**Rancho Las Virgenes
Regional Facilities Expansion IV**

Solids Handling and Composting Facilities

LAS VIRGENES MWD / TRIUNFO CSD
RANCHO LAS VIRGENES - REGIONAL FACILITIES EXPANSION IV
SOLIDS HANDLING AND COMPOSTING FACILITIES

ANAEROBIC DIGESTERS AND
 DIGESTER PUMP STATION

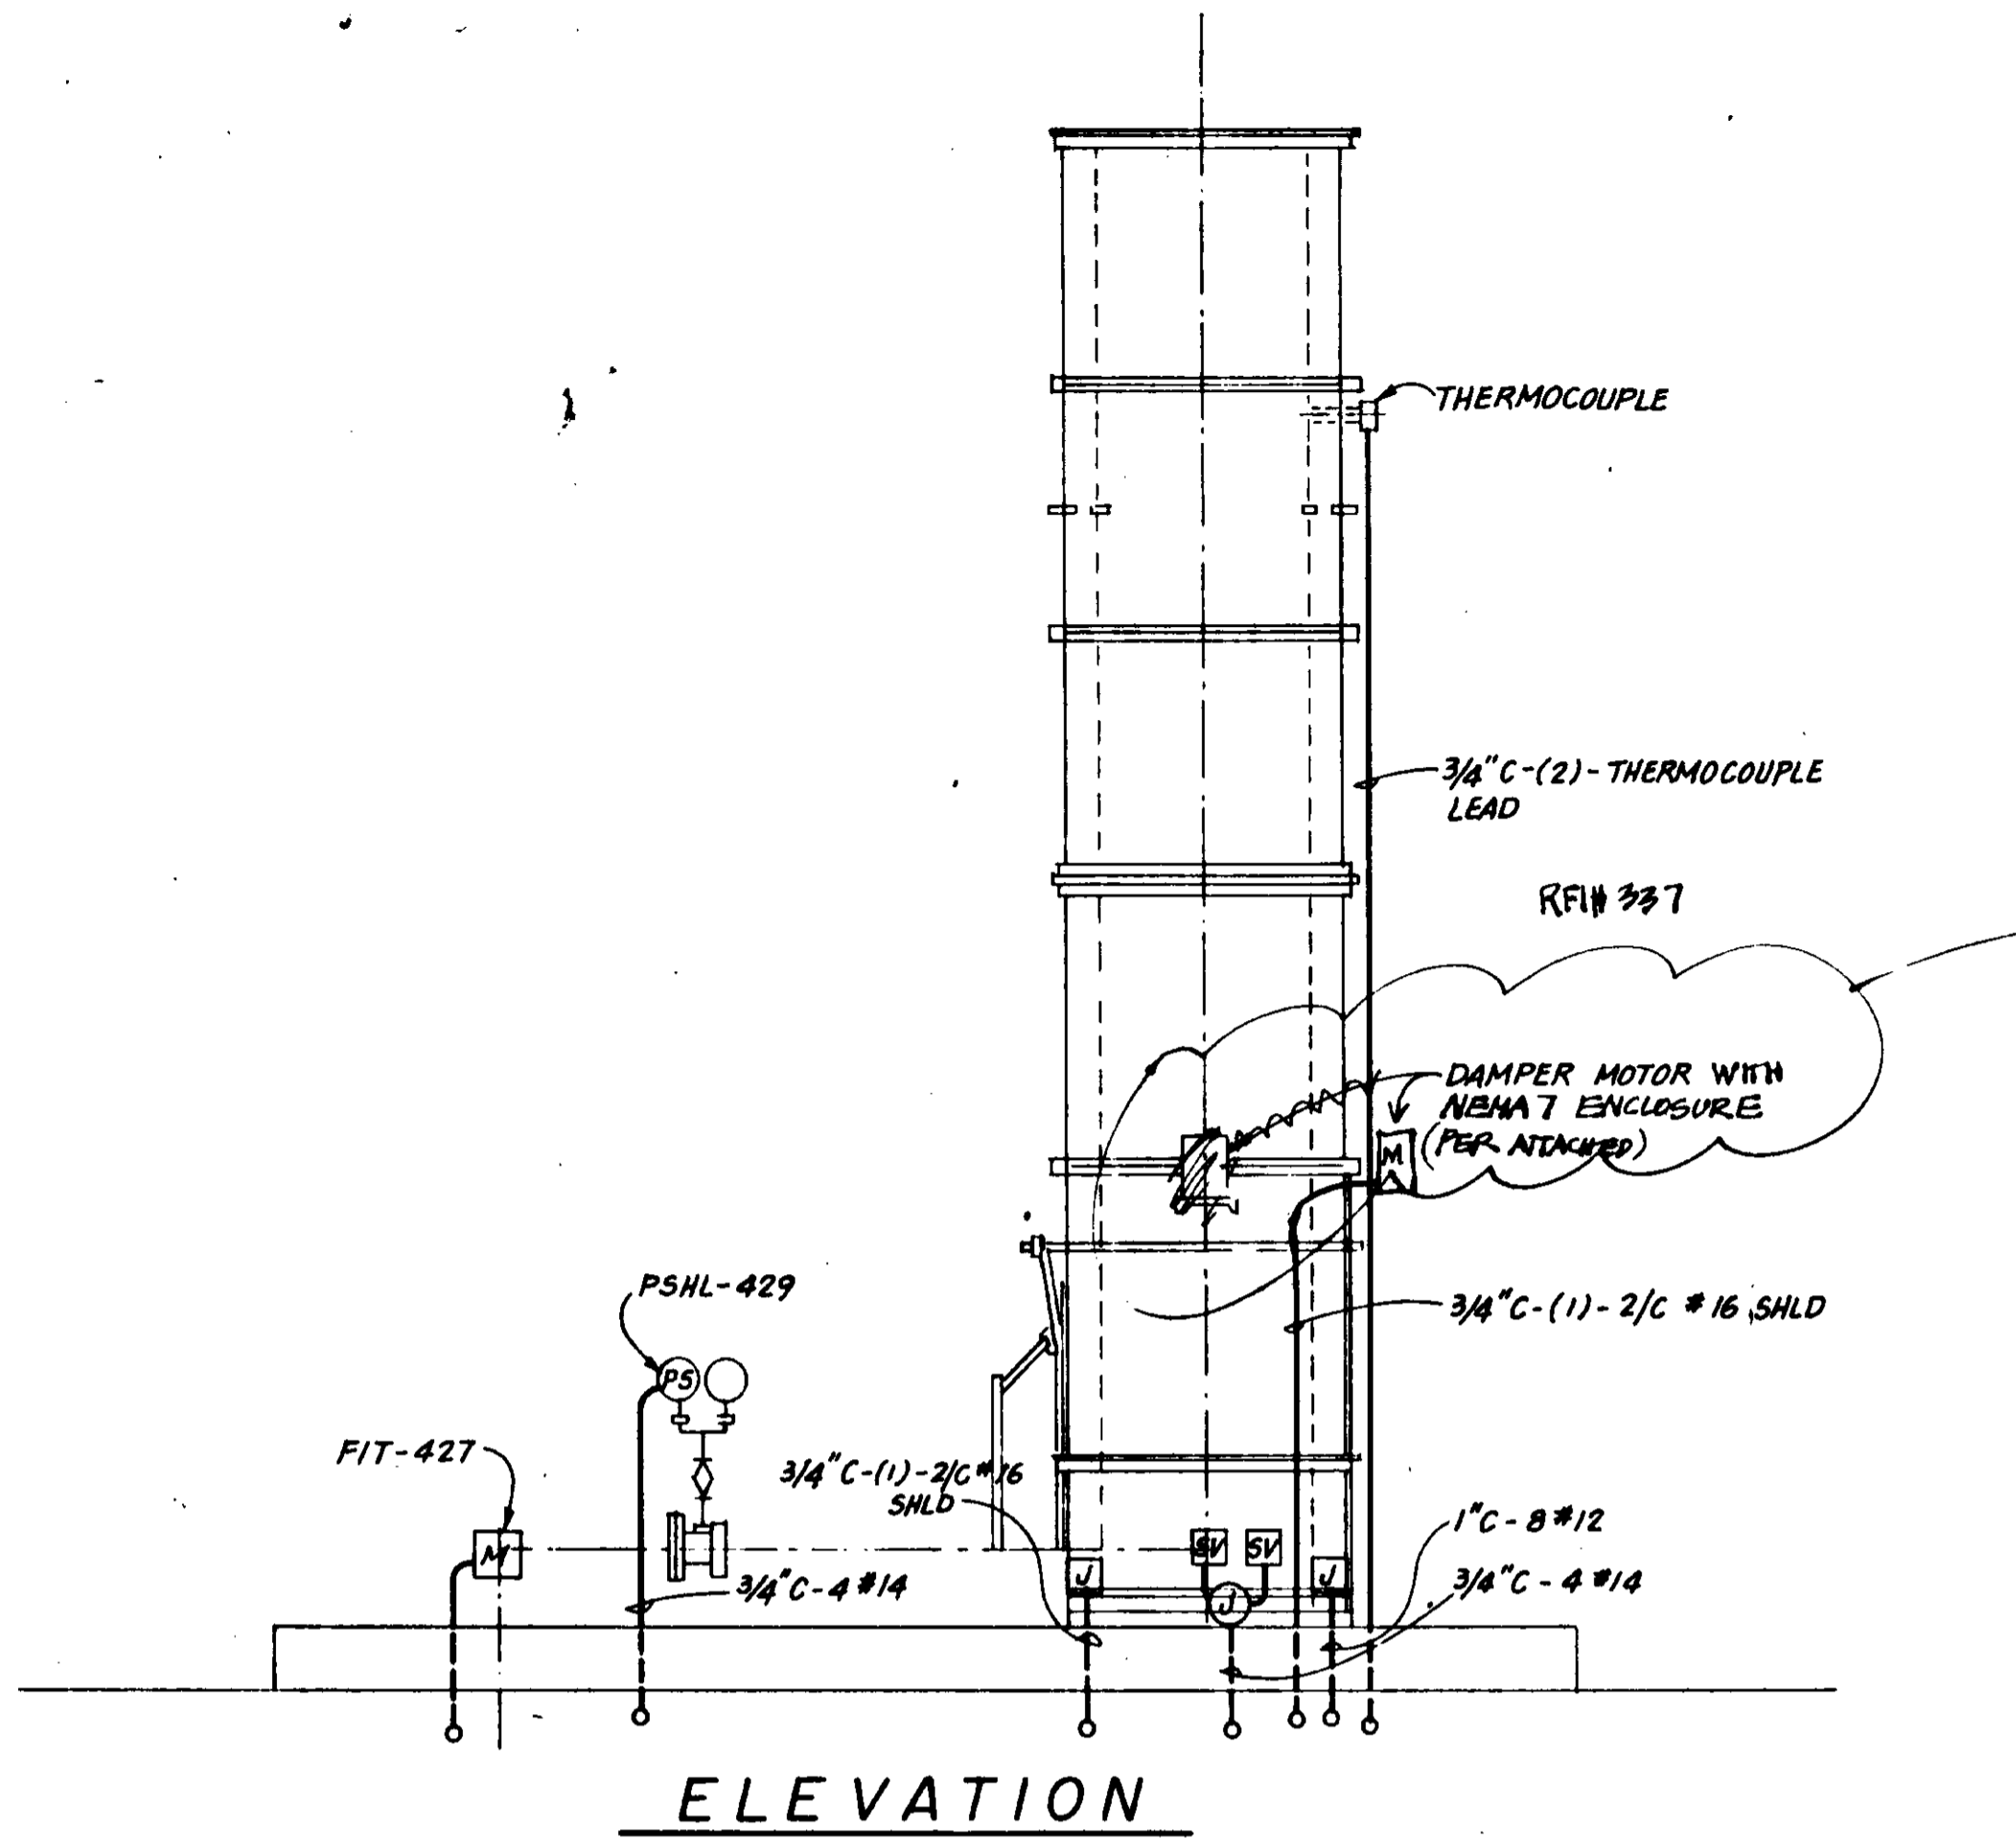
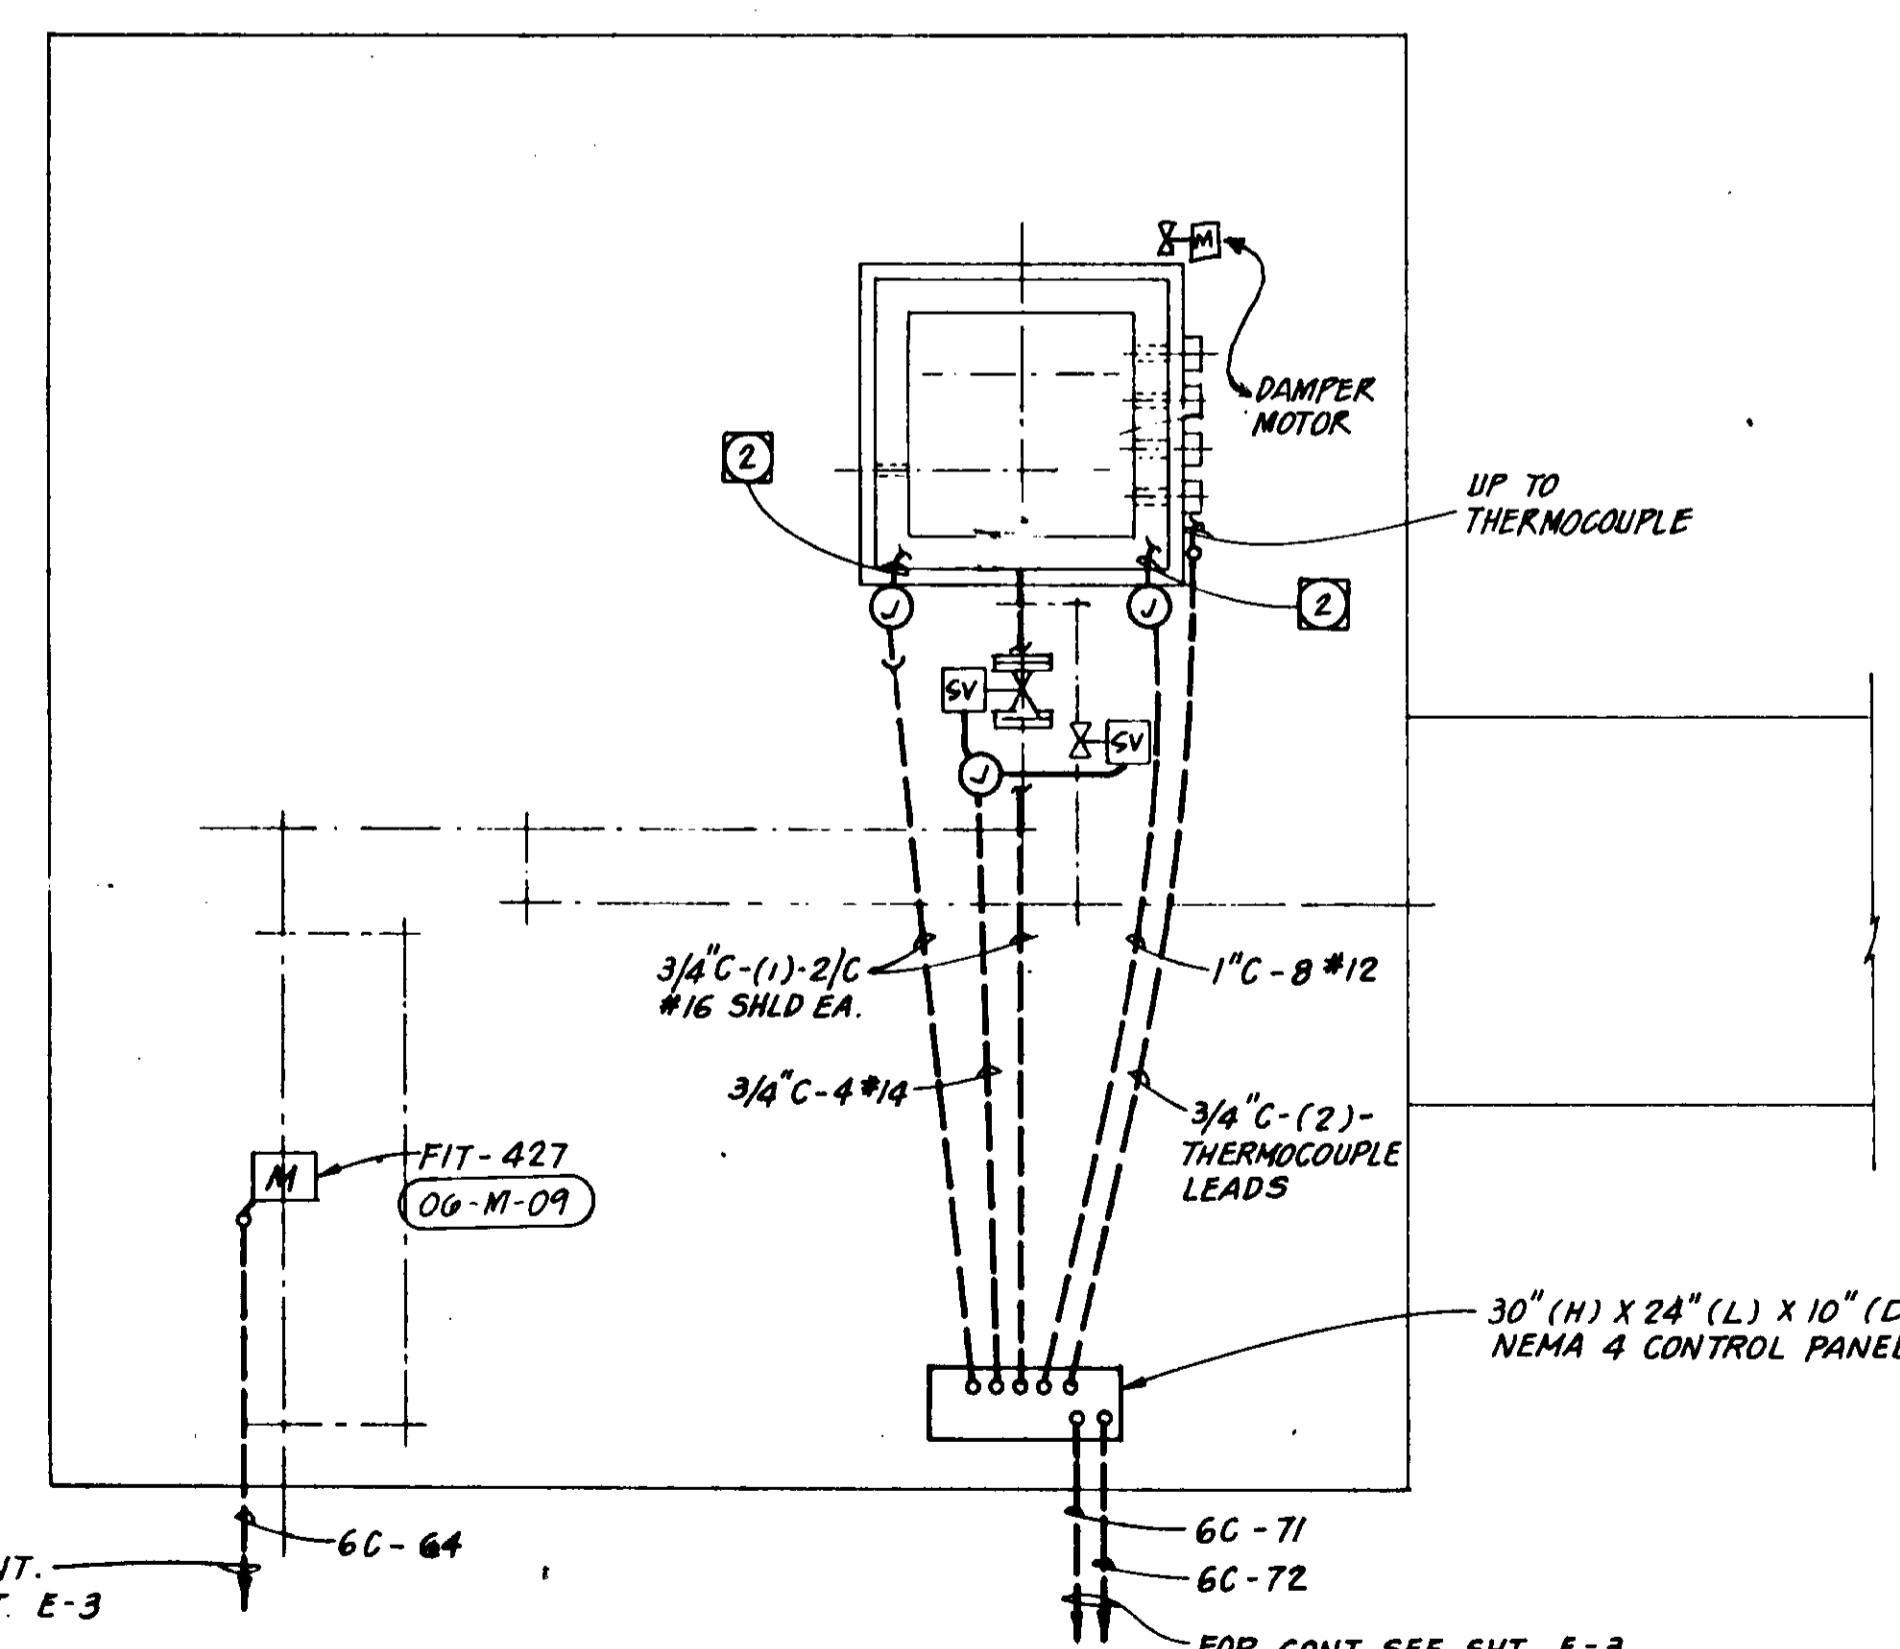
PROVIDE EXPLOSION-PROOF HOUSING

RFI# 337
 ALL MOTORS INSTALLED IN CLASS I OR II AREAS SHALL BE EXPLOSION PROOF. (SEE SPECS: 16040 2.2 D.)
